NUMBER: B400R1046-A

SERVICE BULLETIN

Ride: GIANT GONDOLA WHEEL

Subject: Gondola Door Adjustment

RIDE SERIAL NUMBERS 400-001-88 THROUGH 400-012-89

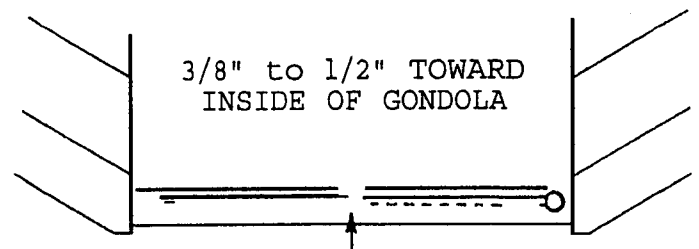
With the doors closed, and the cam pin against the stop bolt, check the alignment of the door panels. The doors must be angled slightly toward the center of the gondola as shown, not flush with each other.

If adjustment of the doors is required, follow the procedure on the reverse side of this bulletin.

RIDE SERIAL NUMBERS 400-013-89 AND ON

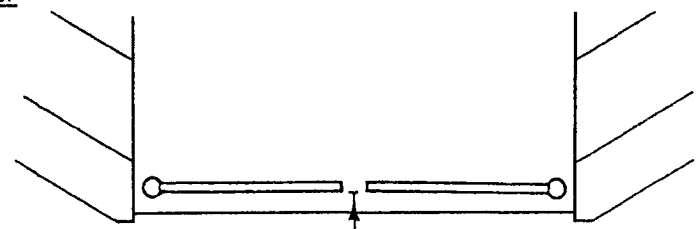
With the doors closed, and the cam pin against the stop bolt, check the alignment of the door panels. The doors must be flush with each other.

If adjustment of the doors is required, follow the procedure on the reverse side of this bulletin.
